Novi Town Center Building I Demo and Reconstruction SP 09-23A

PLAN REVIEW CENTER REPORT

Novi Town Center Bldg. I Demo

SP #09-23A

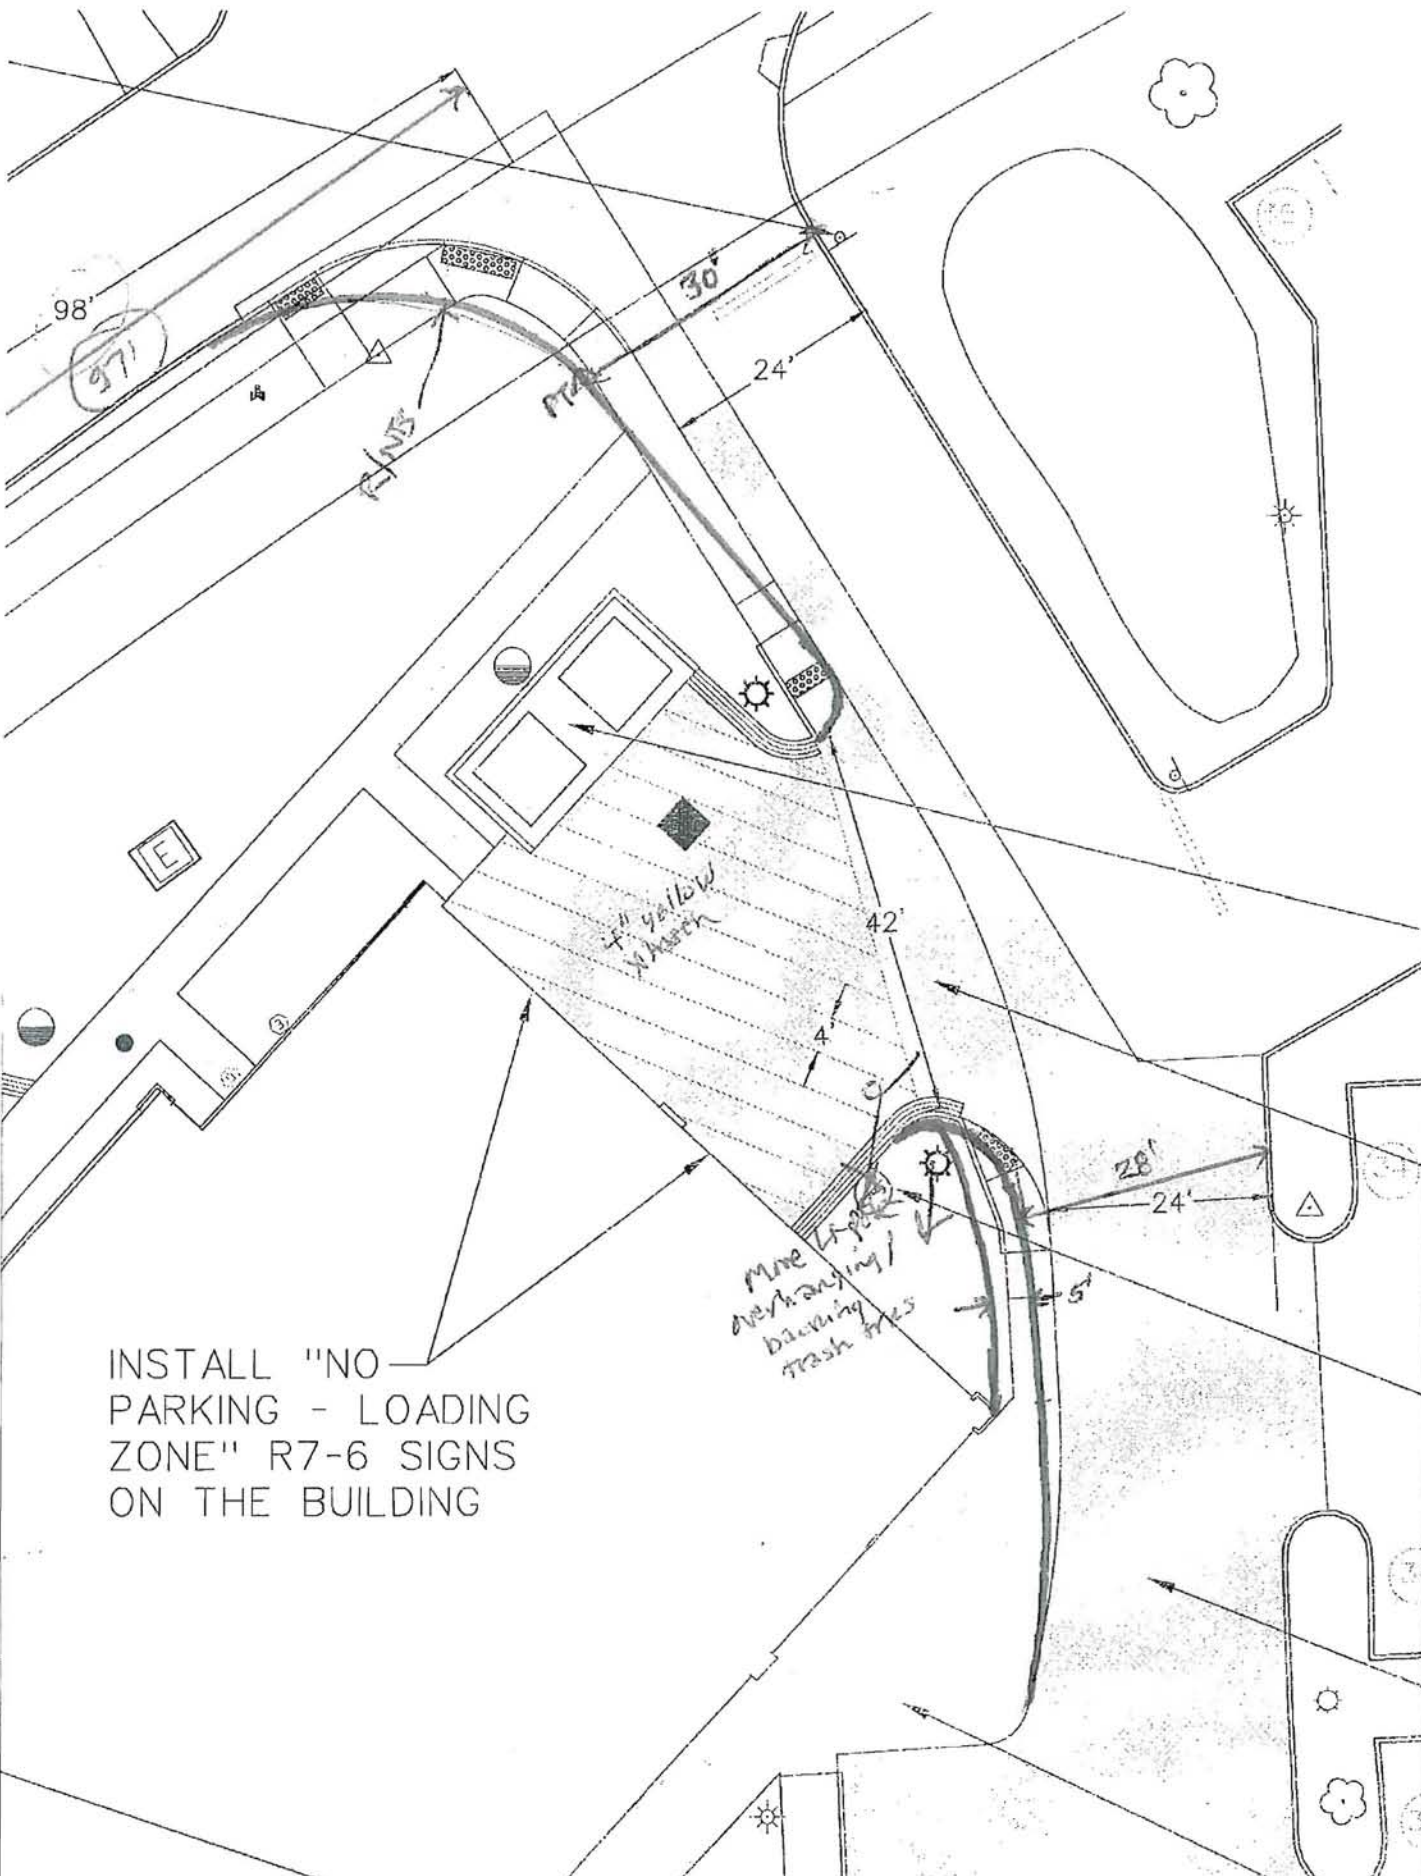
3. A light pole and "No Parking – Loading Zone" sign are proposed on the south side of the dumpster pad/service area. Based on the AutoTurn analysis included on Sheet C7.1, we are concerned that a trash truck or service vehicle would back into both of them. **Birchler Arroyo recommends the proposed light pole be relocated a safer distance from the service area, and the sign be removed altogether.** The other two "Loading Zone" signs proposed on the east face of the building should suffice.

INSTALL "NO
PARKING - LOADING
ZONE" R7-6 SIGNS
ON THE BUILDING

4" yellow
whorl

Photo No. 2

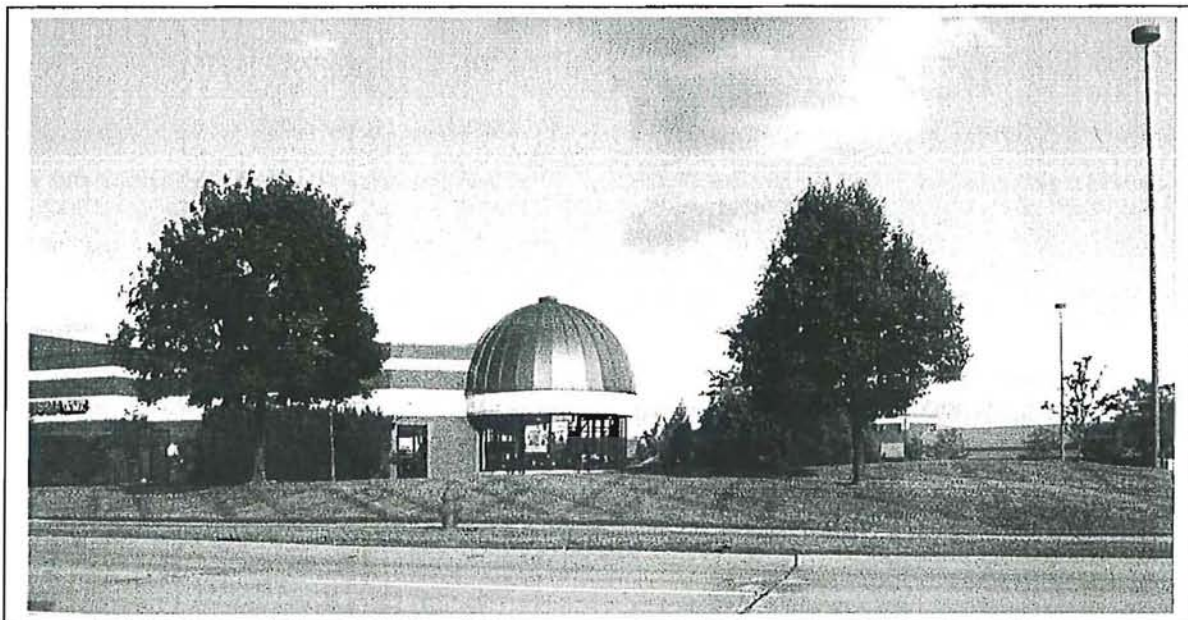
With this submittal the applicant has revised the design to address the above as well as other points raised in our previous review. The dome element at the west end of the building has been preserved and will be painted to match other metal roofs. The new facade treatment consisting of brick piers and an EIFS cornices has been introduced wrapping around the base of the dome. This creative solution will serve to visually tie the dome into the new facade while preserving the dome as a landmark visual element. The east dome has been eliminated however this is consistent with the overall design given that the dumpster and service delivery area has been relocated to that location. The elimination of the central dome on the south facade is acceptable given that a nicely designed pediment has been introduced in its place. The pediment actually harmonizes more readily with the clock tower beyond than the original domed element. The clock tower (Photo No. 3) has been preserved and its existing standing seam roof will be painted to match other roofs. Overall the unique identity of the building has been preserved and the building will continue to serve as the signature building of the Novi Town Center.

With respect to the use of non-copper colored roofs the proposed materials are consistent with other recent facade upgrades for which the Planning Commission has granted Section 9 waivers for the use of green, blue and black standing seam metal. The Cement Plaster is an existing material and the comparatively small percentages are not inconsistent with the overall design of the building. The proposed design complies with the Town Center Ordinances requirement that building be constructed primarily of Brick and Stone.

DATE: 08-12-09
SCALE: 1"=20'
SHEET: C7.1
JOB: 12044

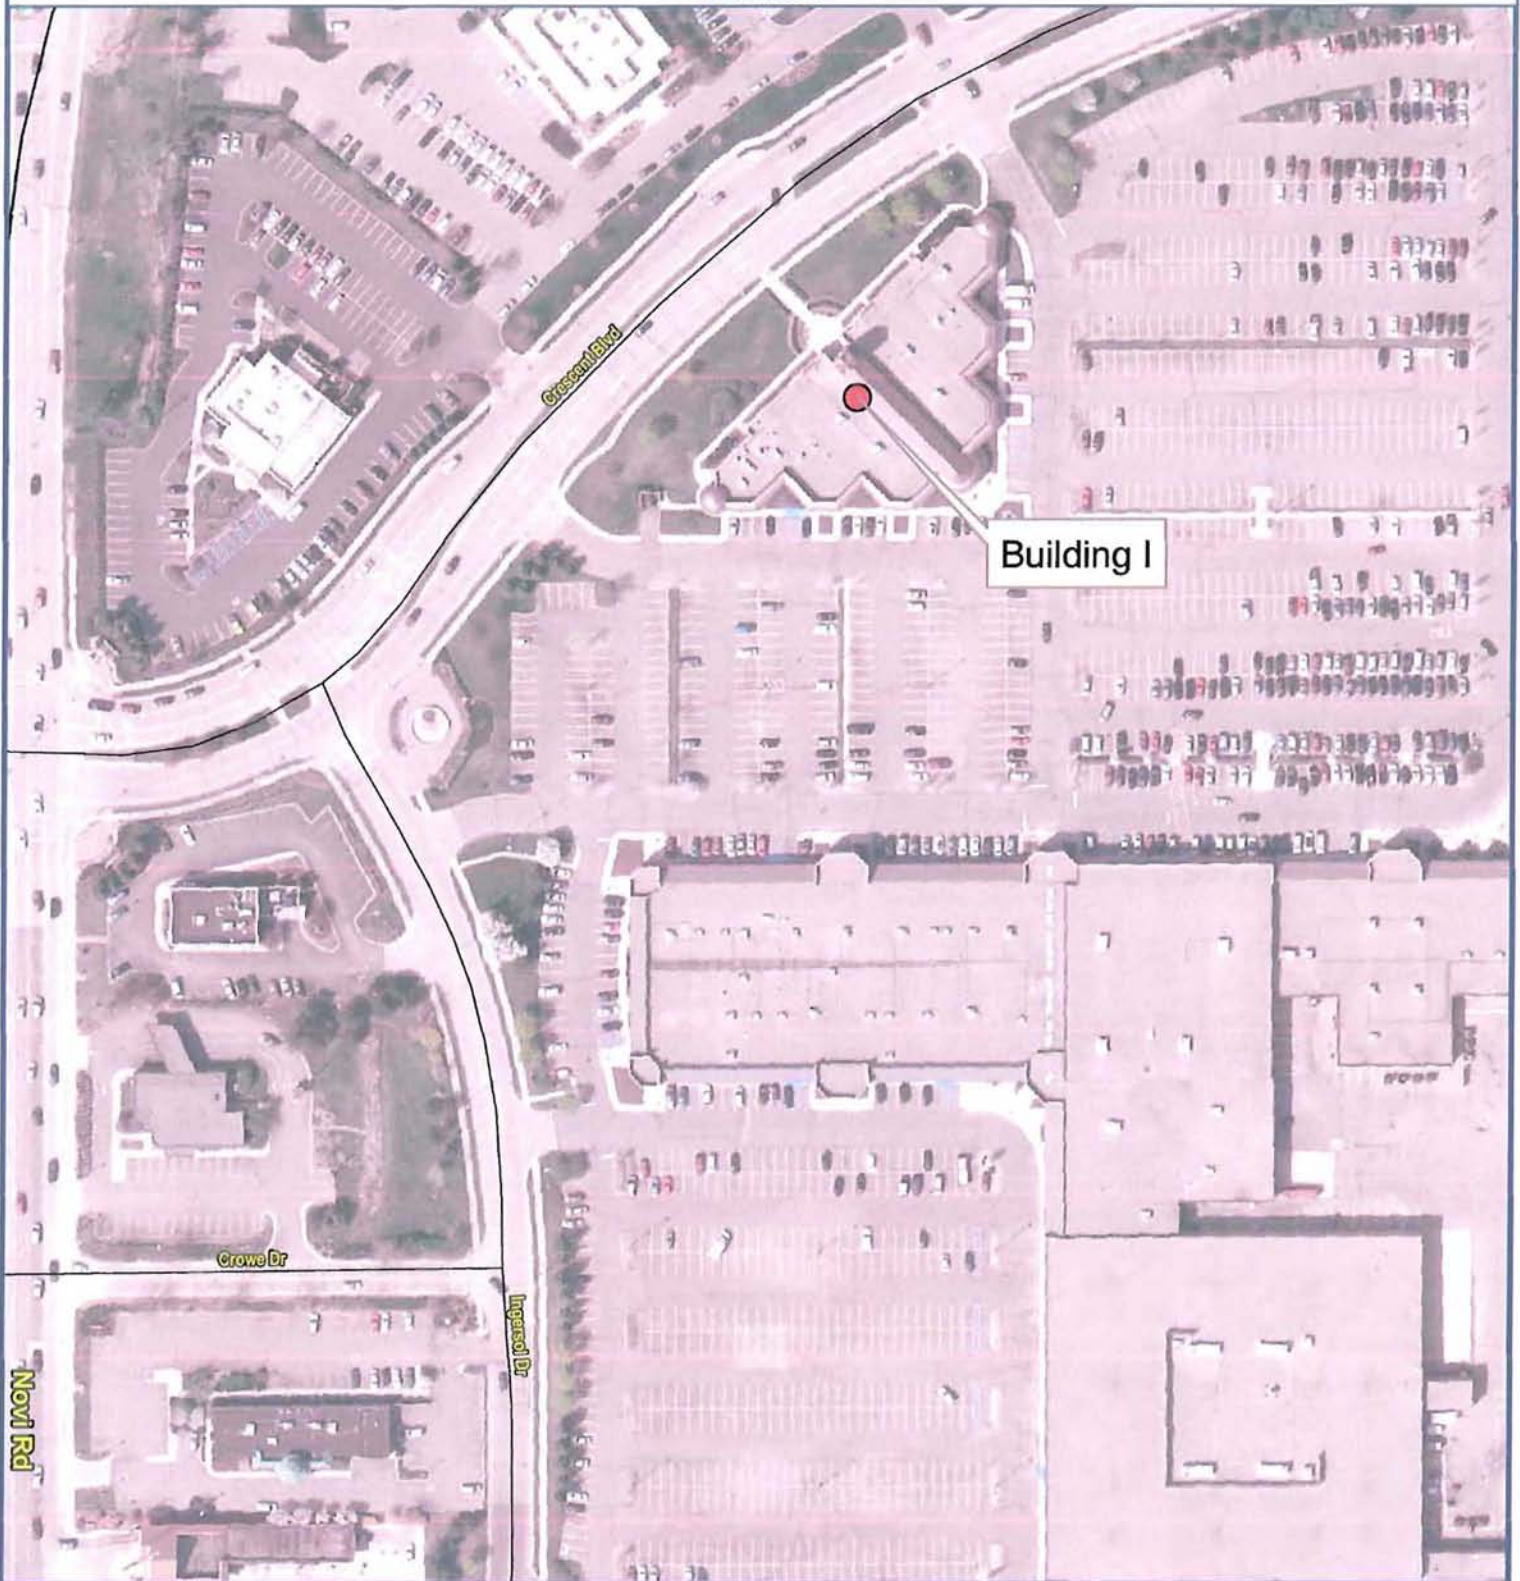
5. A minimum cover depth of 3 feet shall be maintained over all storm sewers. Currently, the section of pipe from CB1 to MH1 does not meet this standard. Grades shall be elevated and minimum pipe slopes shall be used to maximize the cover depth. In situations where the minimum cover cannot be achieved, Class V pipe must be used with an absolute minimum cover depth of 2 feet. Near CB1 there is only 1.5 feet of cover provided. An explanation shall be provided where the cover depth cannot be provided.
6. Show a more detailed profile of the outlet structure (MH#2).
7. List the class of concrete pipe used in the profiles on sheet C7.1.

10. The pervious pavement cross section shall be revised. Either use 18-inches of 21AA aggregate for a base, or a combination of 12-inches of 6A and 6-inches of 21AA on top. This may also add more porosity in the base. The base and sub-base shall meet 95% compaction. Also, the HDPE perforated pipe shall also be socked. Please show all corrections on sheet C7.1 in the plan.

10. The proposed new one-way driveway is 18 feet wide (measured back-to-back of curb), 2 feet wider than the City standard of 16 feet (per DCS Fig. IX.2). Sheet C7.1 includes an AutoTurn analysis which demonstrates that a 30-foot commercial vehicle (such as a UPS/FedEx truck) will require the additional width to navigate the right turn out of that driveway. This width would also better accommodate City Fire Dept. vehicles, although it is doubtful they would choose to use that driveway for access. The applicant has in our opinion "shown cause" for the wider driveway, consistent with the standards of DCS Fig. IX.2.

We have submitted revised drawings to Birchler Arroyo Associates. We have addressed Items 1 through 11 with our drawings submitted on November 11 and 12. Upon their review, it is understood that they now recommended
